IE Circular No. 79-13

REPLACEMENT OF DIESEL FIRE PUMP STARTING CONTACTORS

No. 74T 13-3A

New Components Available For Industrial Fire Pumps (NH-220-IF, N-855-F, NT-855-F1, and NT-855-F2 Series Engines)

Fig. 2 Magnetic Switch

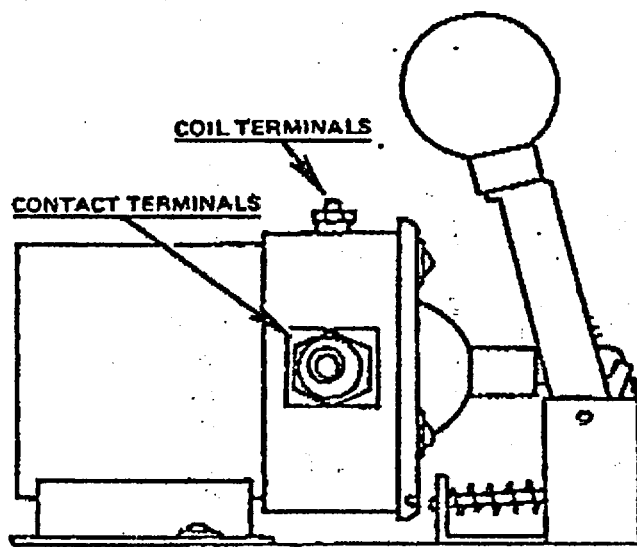
A new high pressure fuel pump shut-off valve Part No. 216930, Fig. 1, (optional field replacement) and magnetic switch Part No. 217588, Fig. 2, have been released to improve operation of inline 6 cylinder Industrial Fire Pump engines.

When replacing 118848 Magnetic Switch, 199573 DC Relay Contactor and 212461 Wiring Harness in the field they should be replaced with new design components.

Caution: When replacing 118848 Magnetic Switch and 199573 DC Relay Contactor with 217588 Magnetic Switch always check the controller relay for maximum current draw. The new 217588 Magnetic Switch has a 6 ampere draw whereas the old combination has approximately 3 amperes draw. Where necessary the controller relay can usually be replaced. Contact local controller representative.

A new wiring harness, AR-12498, which includes two (2) Part No. 217588 Magnetic Switches, wiring harness and mounting hardware must be used when making conversion.
